AGENDA

PLANNING & ZONING COMMISSION REGULAR MEETING TUESDAY, MAY 7, 2024 - 3:30 PM MCALLEN CITY HALL, 1300 HOUSTON AVENUE CITY COMMISSION CHAMBERS, 3RD FLOOR

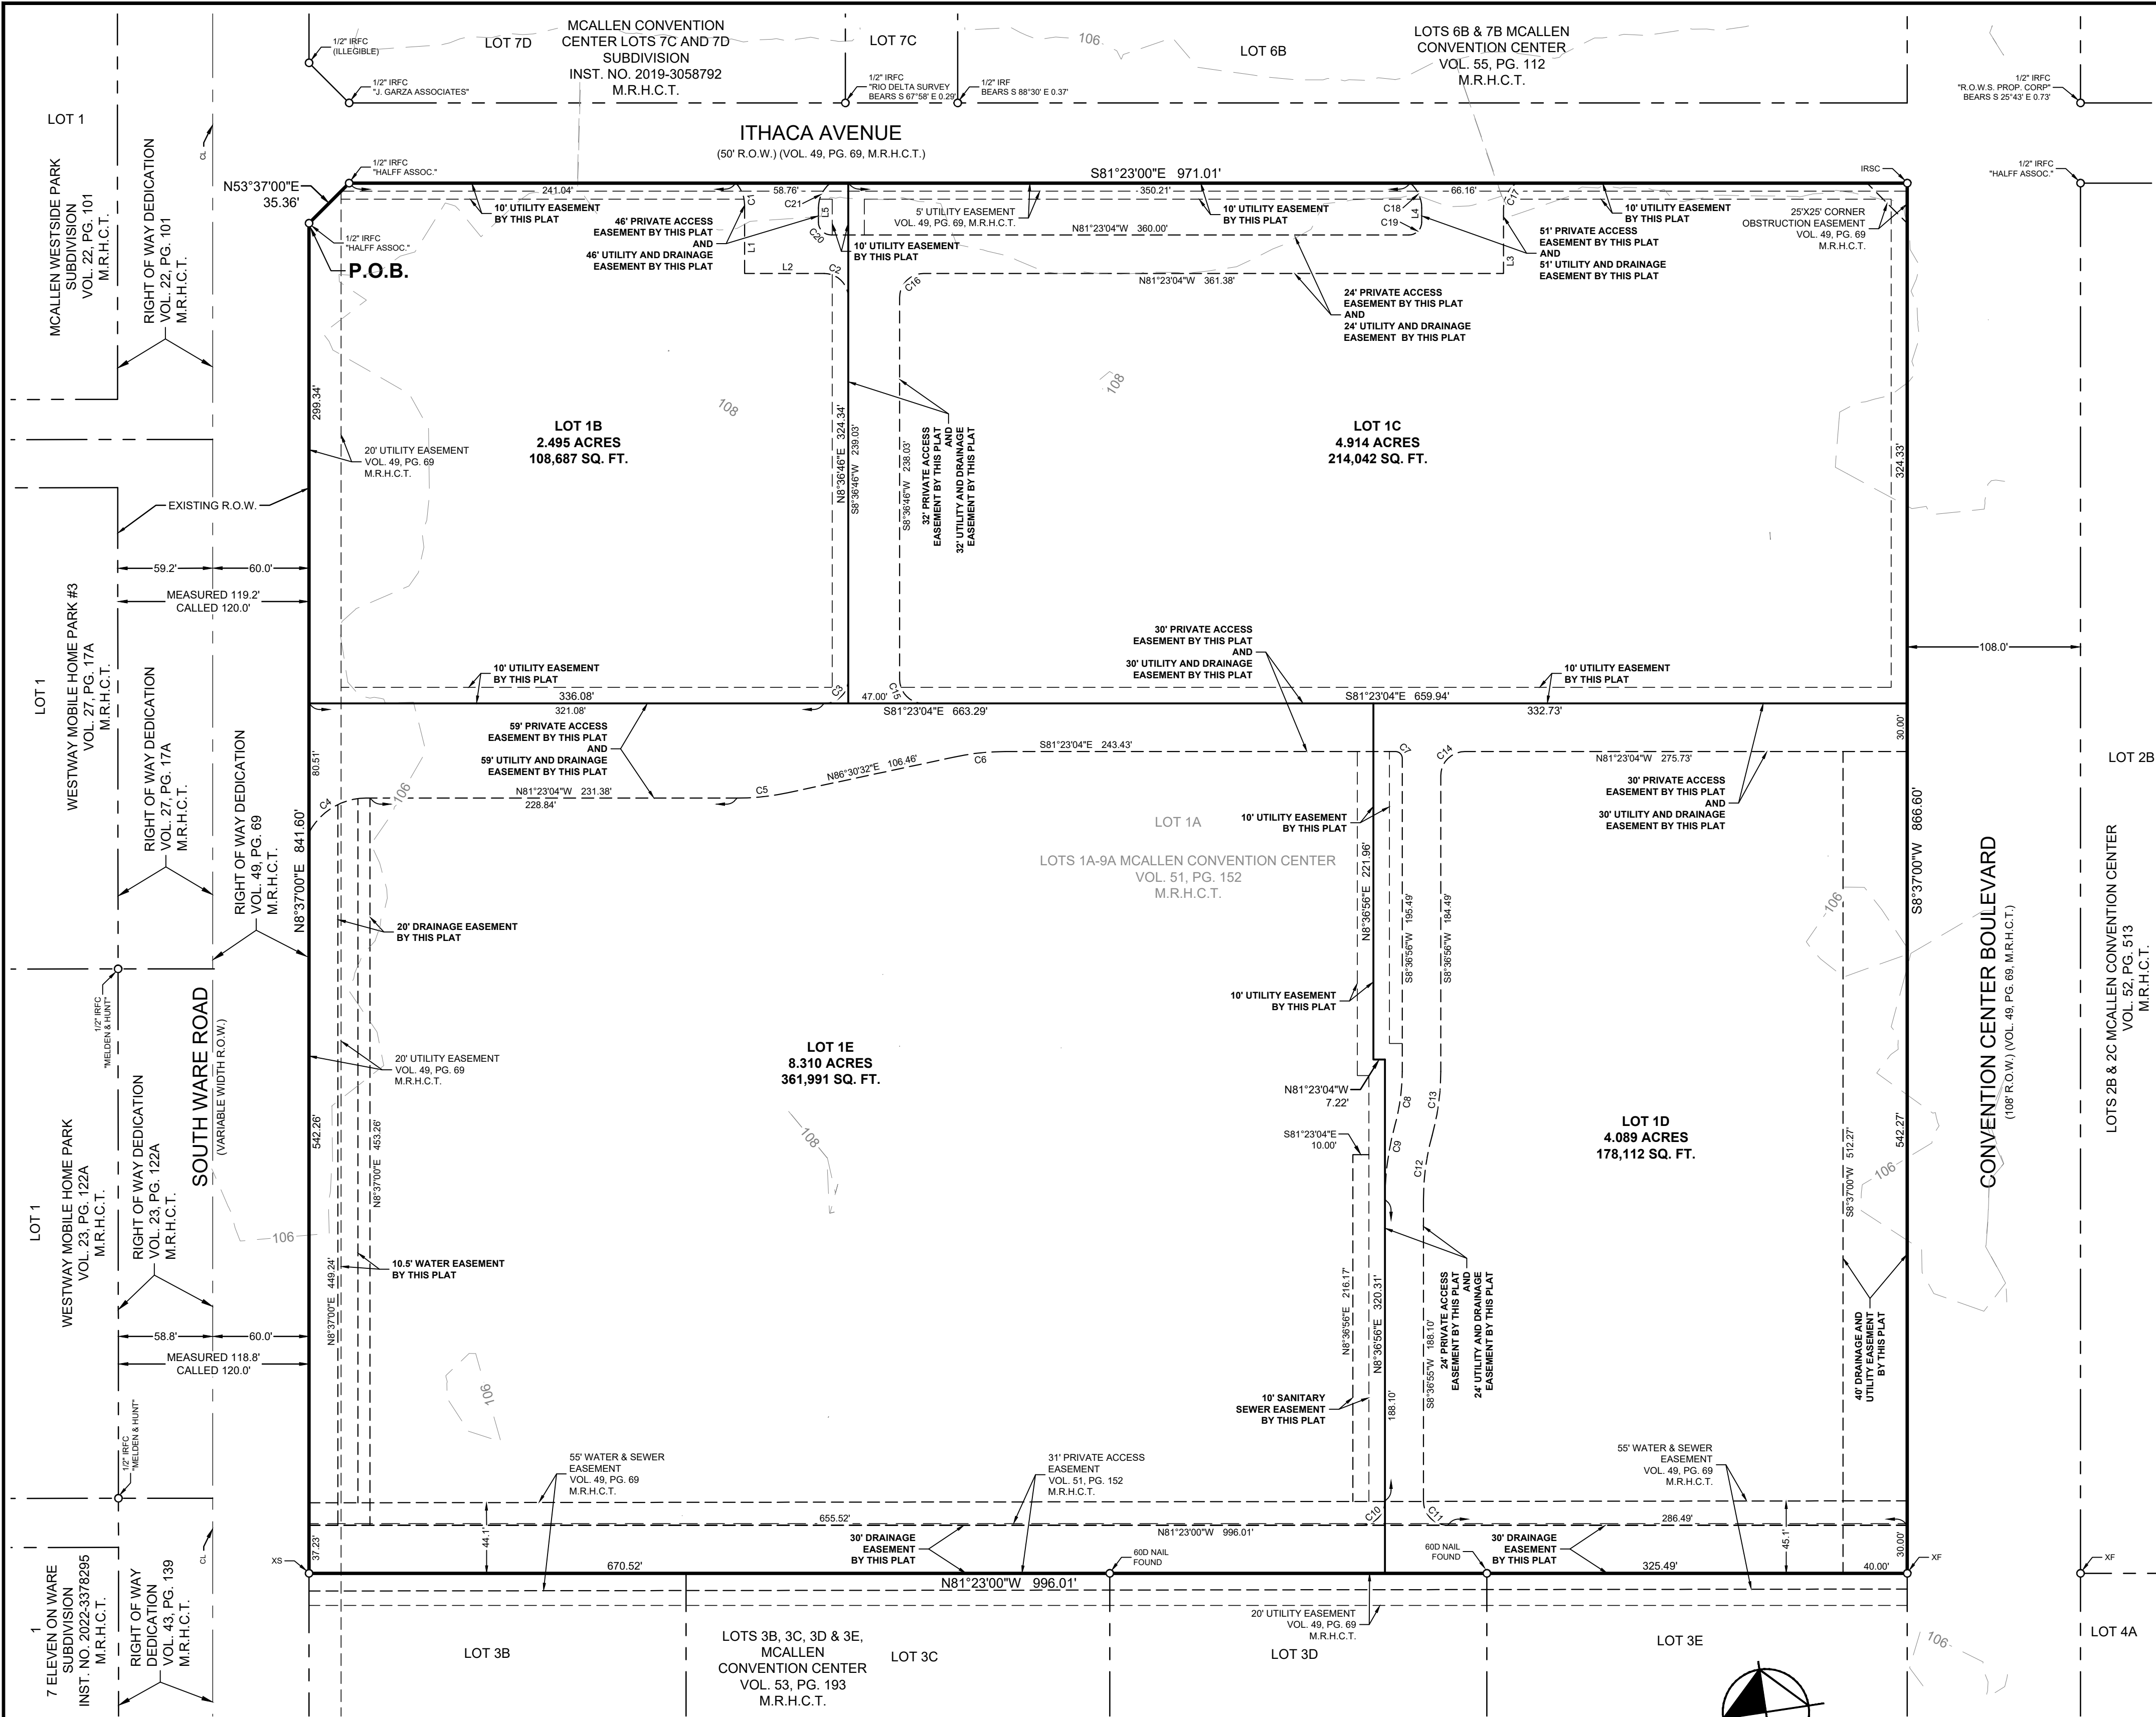
South Ware Road: Dedication needed for 60 ft. from centerline for 120 ft. total ROW
Paving: By the State Curb & gutter: By the State
Revisions needed:
- Label centerline and "Existing R.O.W." to determine R.O.W. dedication requirement prior to final.
- All ROW requirements must be addressed prior to final.
**Subdivision Ordinance: Section 134-105
**Monies must be escrowed if improvements are required prior to recording
**COM Thoroughfare Plan

ROW: 20 ft. Paving: 16 ft.
*Alley/service drive easement required for commercial properties
- Proposing: Variable width access, utility, and drainage easement (24 ft. to 59 ft.)
- Clarify the overlap of private access, utility, and drainage easements prior to final. The overlap requires all development departments' approval prior to final.
- Clarify the 30 ft. access, utility, and drainage easements on the SOUTH side of subdivision prior to final, since it overlaps the existing 31 ft. private access easement and 55 ft. water and sewer easement.
**Subdivision Ordinance: Section 134-106

COMMENTS	
<p>Comments:</p> <ul style="list-style-type: none">-If any additional easements to added, reference must be done by this plat or by Document #.- Add dimensions to clarify how many feet of the existing 55 ft. water and sewer easement in on this property (show at multiple points) prior to final. Dimensions to be shown on all easements.- All signature blocks must comply with Sec. 134-61 of the Subdivision Ordinance prior to recording.- Legal description of all adjacent lots on all sides are required on the plat prior to recording.- Any abandonment must be done by separate process/document, not by this plat prior to final. <p>*Must comply with City's Access Management Policy.</p>	Applied
RECOMMENDATION	
Recommendation: STAFF RECOMMENDS APPROVAL OF THE SUBDIVISION IN FINAL FORM, SUBJECT TO THE CONDITIONS NOTED.	Applied

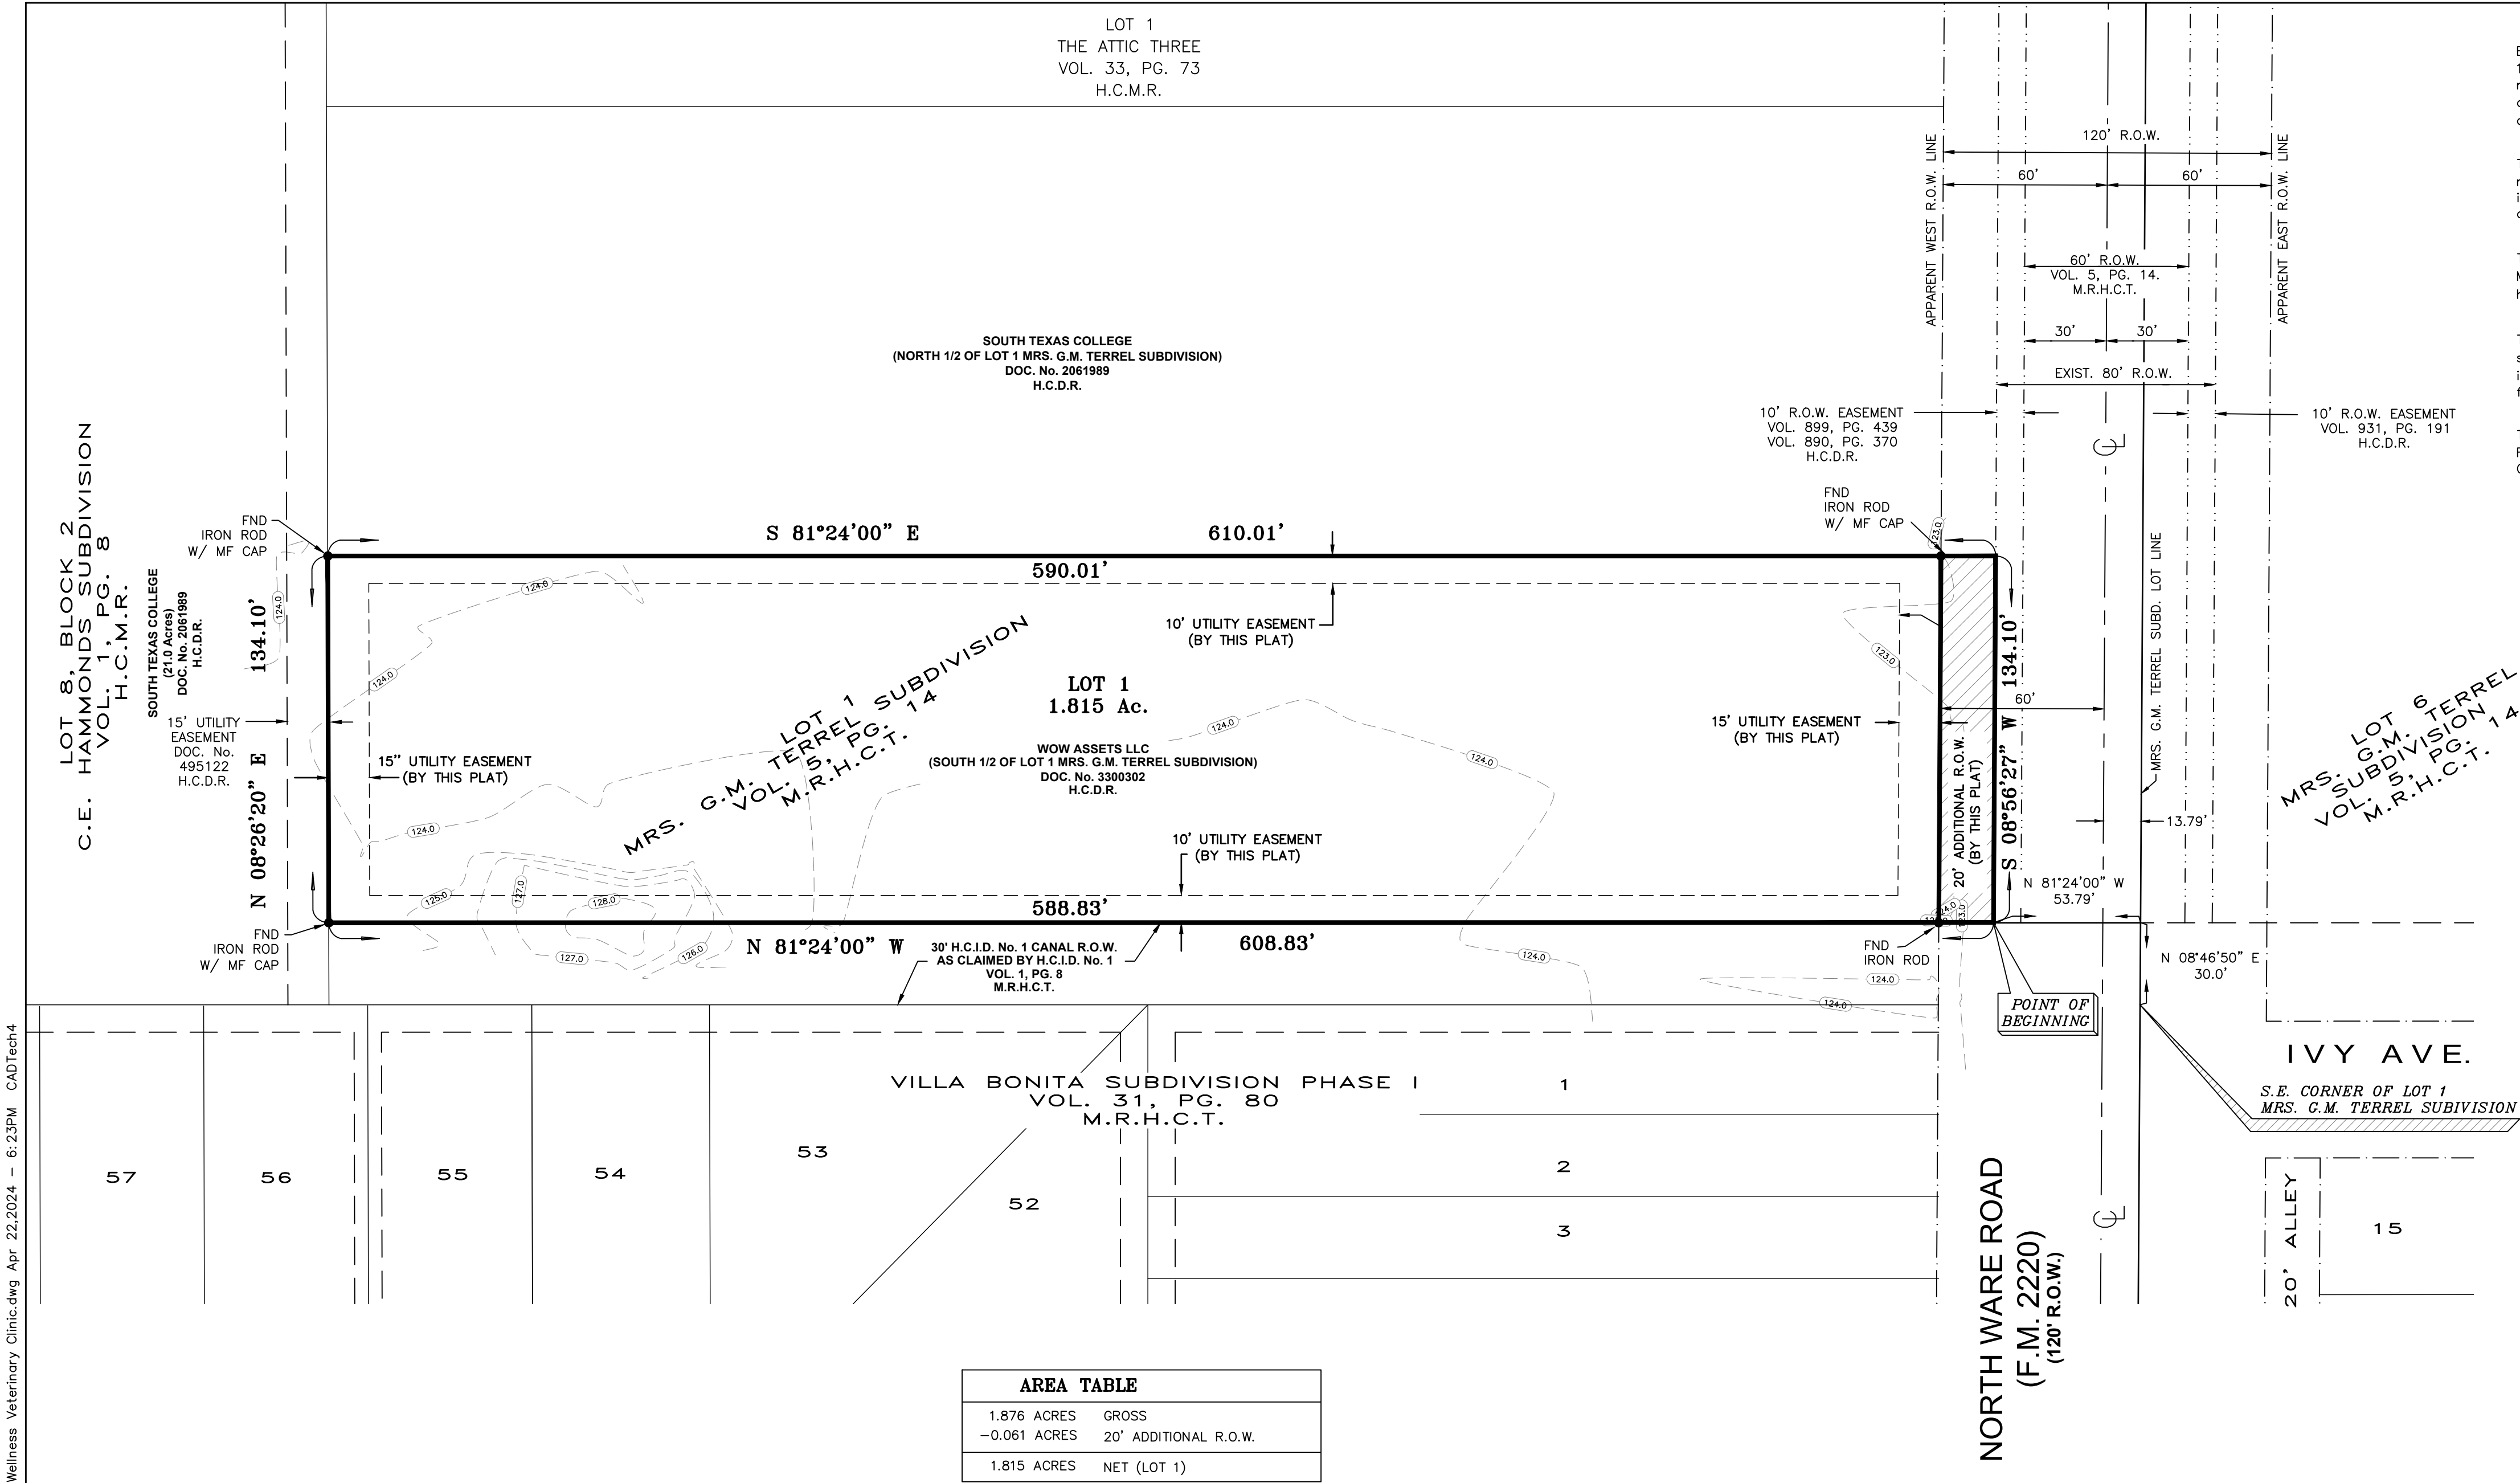
-Please add label as required: EXISTING, TOTAL, etc. prior to final.

-Provide a COPY of the R.O.W. document for staff review prior to final.

SETBACKS	
<p>* Front: In accordance with the Zoning Ordinance or greater for approved site plan or easements or inline with existing structures, whichever is greater applies. Revisions Needed: -Revise plat note as shown above prior to final. Plat submitted on 01-24-2024 has note revised. **Zoning Ordinance: Section 138-356</p> <p>* Rear: In accordance with the Zoning Ordinance or greater for approved site plan or easements, whichever is greater applies. Proposed: 10 ft. or greater for site plan (approved) Revisions Needed: -Revise note as shown above prior to final. Plat submitted on 01-24-2024 has note revised. **Zoning Ordinance: Section 138-356</p> <p>* Sides: In accordance with the Zoning Ordinance or greater for approved site plan or easements, whichever is greater applies. Proposed: As per zoning ordinance or site plan (approved) Revisions Needed: -Revise note as shown above prior to final. Plat submitted on 01-24-2024 has note revised. **Zoning Ordinance: Section 138-356</p> <p>* Corner _____ **Zoning Ordinance: Section 138-356</p> <p>* Garage _____ **Zoning Ordinance: Section 138-356</p> <p>*ALL SETBACKS ARE SUBJECT TO INCREASE FOR EASEMENTS OR APPROVED SITE PLAN</p>	Applied

<p>* Site plan must be approved by the Planning and Development Departments prior to building permit issuance. -Remove plat note #13 as it is required but not a required plat note. Plat submitted on 01-24-2024 has note revised.</p> <p>* Common Areas, any private service drive, gate areas, etc. must be maintained by the lot owners and not the City of McAllen. **Prior to Recording, need to finalize wording for NOTE #15 regarding the maintenance, revise note to say; "ALL COMMON ACCESS, PARKING AND LANDSCAPE AREAS SHALL BE MAINTAINED BY THE LOT OWNER, NOT THE CITY OF MCALLEN." **Prior to Recording, need to finalize wording for NOTE #14 regarding the maintenance, revise note to say; "PROPOSED DETENTION AREAS SHALL BE MAINTAINED BY THE LOT OWNER, NOT THE CITY OF MCALLEN." **REMOVE NOTES #: 12 & 16</p> <p>* Common Areas for commercial developments provide for common parking, access, setbacks, landscaping, etc.</p> <p>* Developer/Homeowner's Association/Owner, their successors and assignees, and not the City of McAllen shall be responsible for compliance of installation and maintenance and other requirements per Section 134-168 of the Subdivision Ordinance, including but not limited to common areas and its private streets. **Section 110-72 applies if private subdivision is proposed. **Landscaping Ordinance: Section 110-72 **Subdivision Ordinance: Section 134-168</p> <p>* Homeowner's Association Covenants must be recorded and submitted with document number on the plat, prior to recording. **Section 110-72 applies if private subdivision is proposed. **Landscaping Ordinance: Section 110-72 **Subdivision Ordinance: Section 134-168</p>	Applied

TRAFFIC	
* As per Traffic Department, Trip Generation approved, no TIA required.	Applied
**As per Traffic Department, TIG approval, no TIA required.	Applied
COMMENTS	
<p>Comments:</p> <ul style="list-style-type: none"> -Please provide documents number for the 30 ft. H.C.I.D. No.1 Canal ROW on the plat and a copy of the document for staff review prior to recording. -Verify if the H.C.I.D. No.1 Canal ROW is outside the plat boundary prior to recording. -Need to submit ownership map of the surrounding properties prior to final to assure that no landlocked property exists which may require additional streets as applicable. **Based on ownership map submitted, no landlocked property is shown. -The name of the owner/developer on the subdivision application does not match the warranty deed. Revised application is needed prior to final. -Provide Documents to verify who is authorized to sign on behalf of the LLC, shown on warranty deed. -Please update application to match ownership. -Please verify that survey metes and bounds match what is stated on the plat. *Must comply with City's Access Management Policy. 	Required
